**TOWN OF NEWBURGH
PLANNING BOARD
TECHNICAL REVIEW COMMENTS**

PROJECT NAME: SERVISS-TWO LOT SUBDIVISION
PROJECT NO.: 2021-07
PROJECT LOCATION: SECTION 14, BLOCK 1, LOT 48
REVIEW DATE: 14 JANUARY 2022
MEETING DATE: 20 JANUARY 2022
PROJECT REPRESENTATIVE: TALCOTT ENGINEERING – CHARLES BROWN, P.E.

Re: Resubmission letter
Town Project No. 2021-07
Serviss Subdivision
1298 Union Avenue
SBL: 14-1-48
R2 Zone
Job No. 20244-HHS

DATE	SCALE	JOB NUMBER	SHEET NUMBER
04/01/2021	1"=30'	20244-HSS	2 OF 4

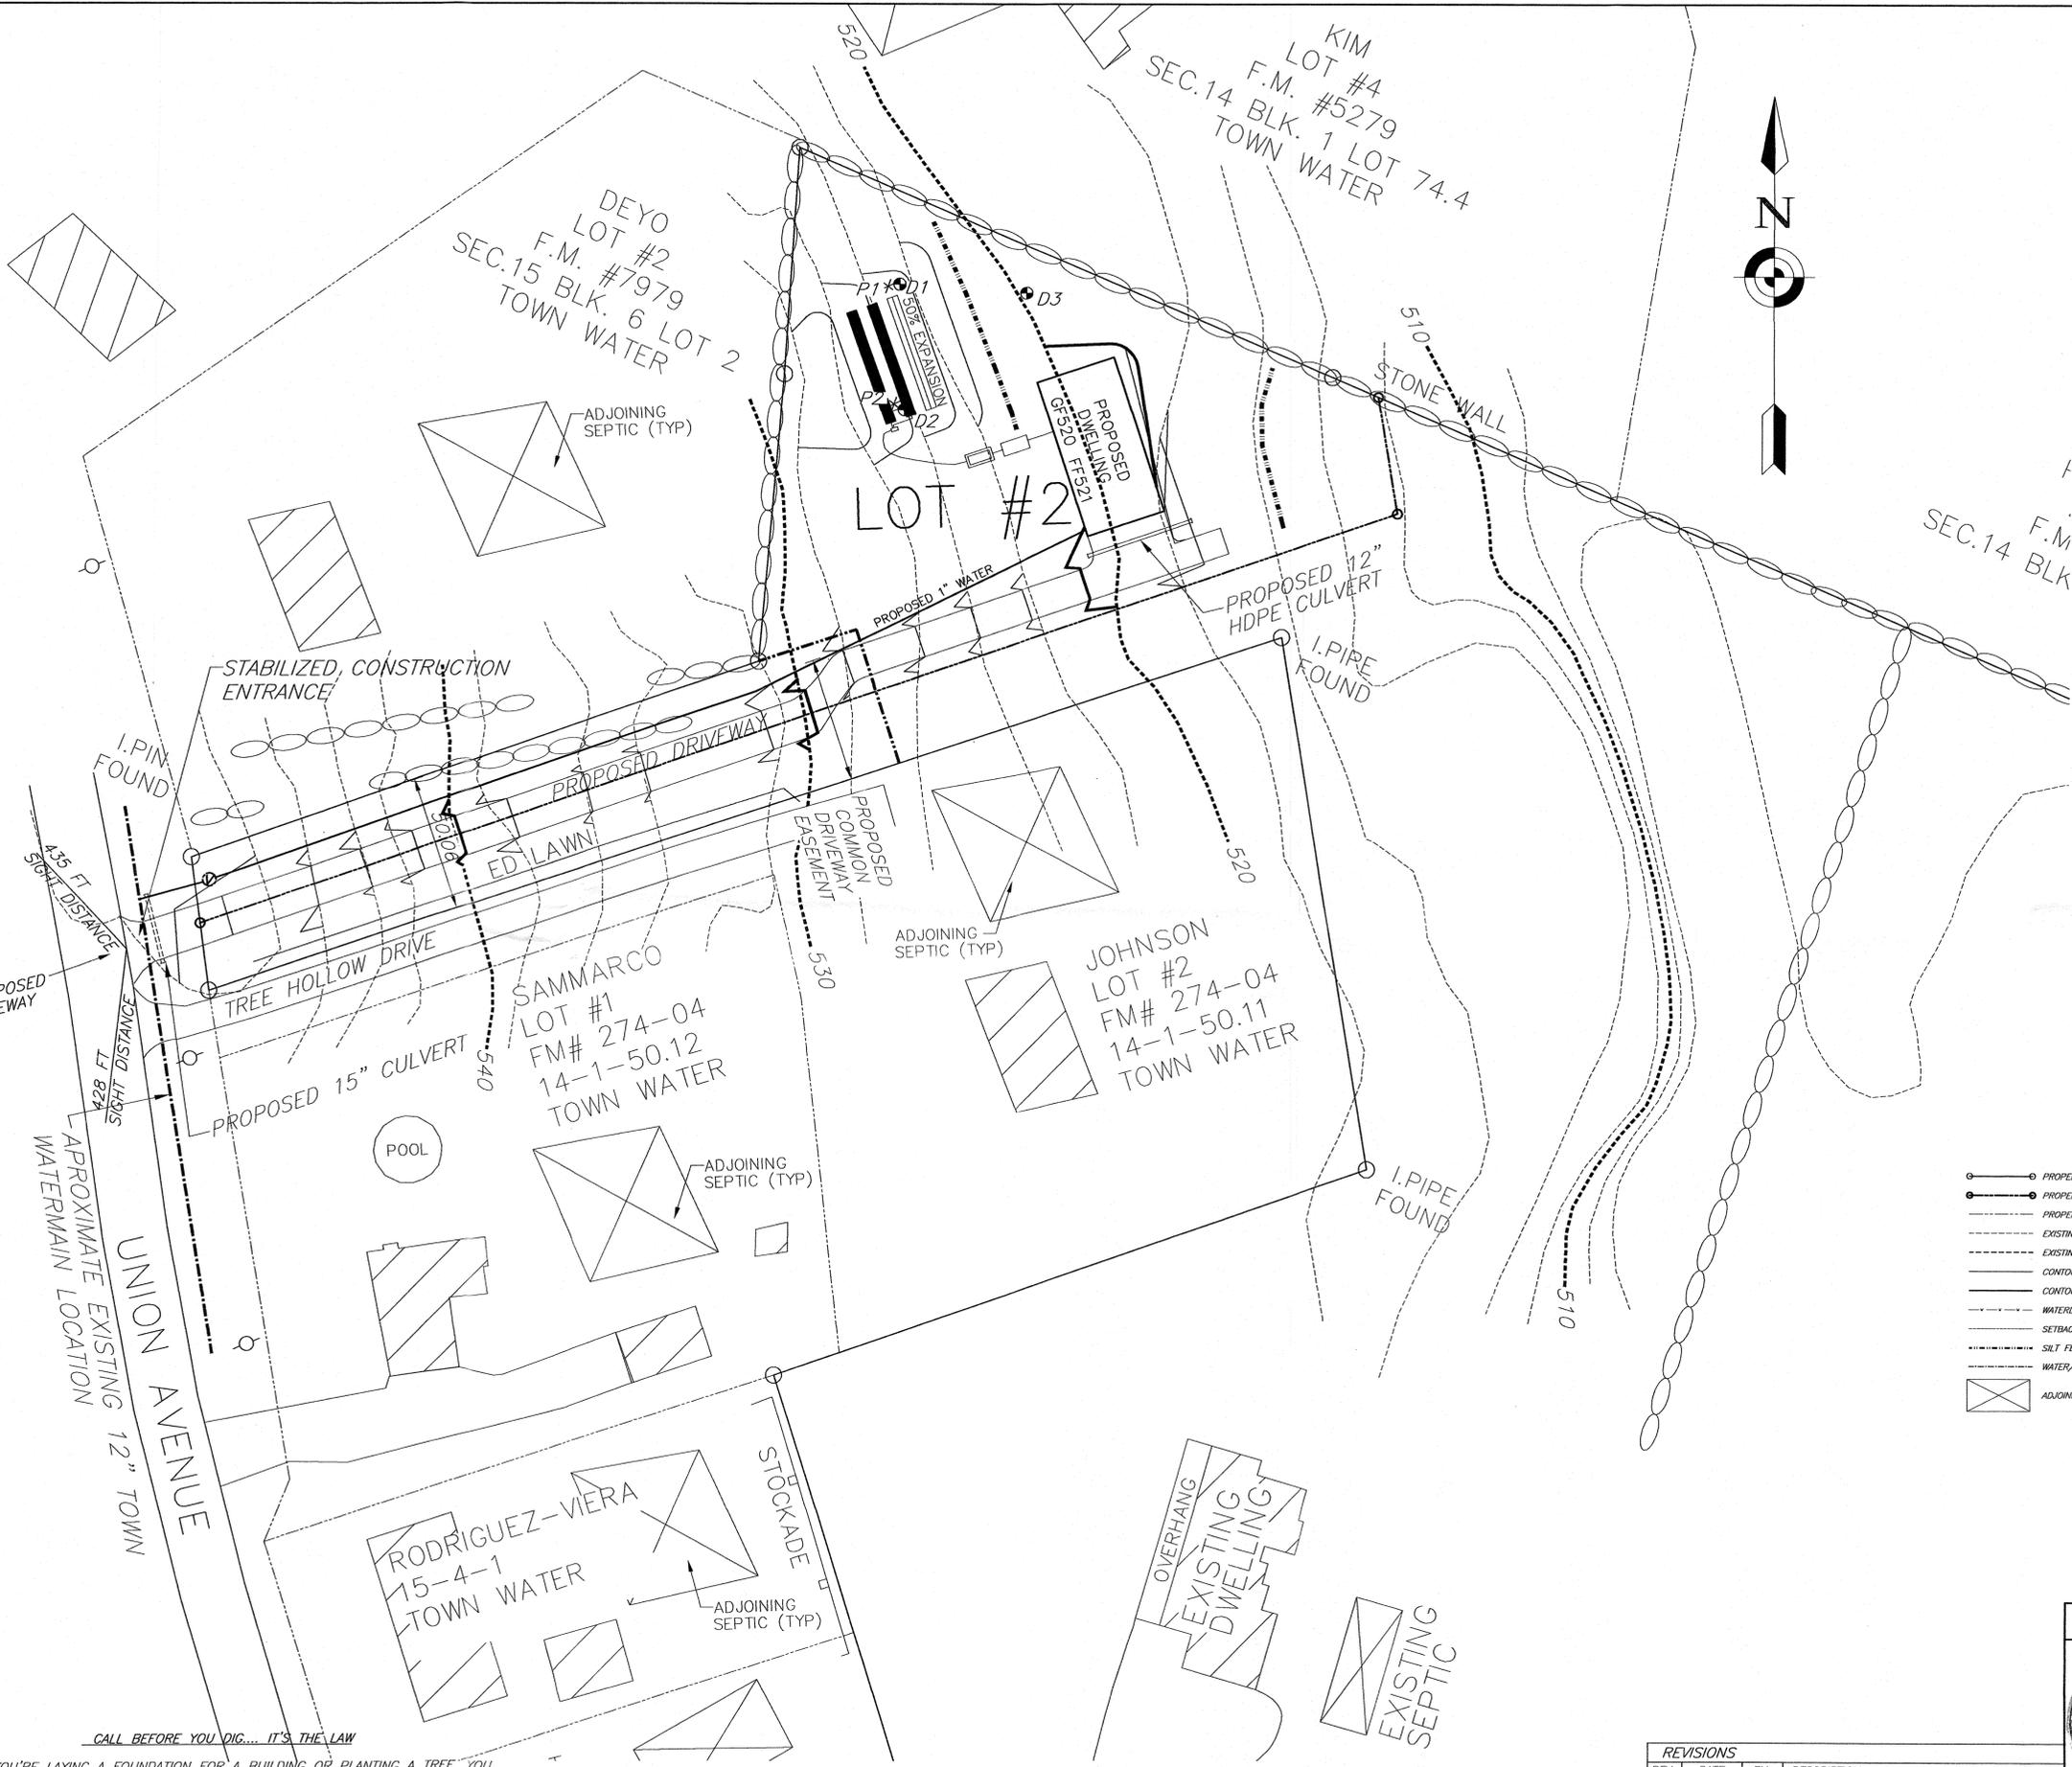
- 1) A set of plans has been sent to the Highway Department and the driveway location has been marked out in paint.
- 2) Location map revised.
- 3) Bulk table revised.
- 4) Proposed water service added to sheet 2.
- 5) Proposed driveway grading added to sheet 2.
- 6) Proposed driveway grading with swales added to sheet 2.
- 7) No response required.
- 8) Revised owners added to sheet 1.
- 9) No response required.
- 10) Adjoining items with 200'.
- 11) Combined entrance has been added to sheet 2.
- 12) Proposed serviced line size has been added to sheet 2.
- 13) Water system notes have been revised on sheet 4.
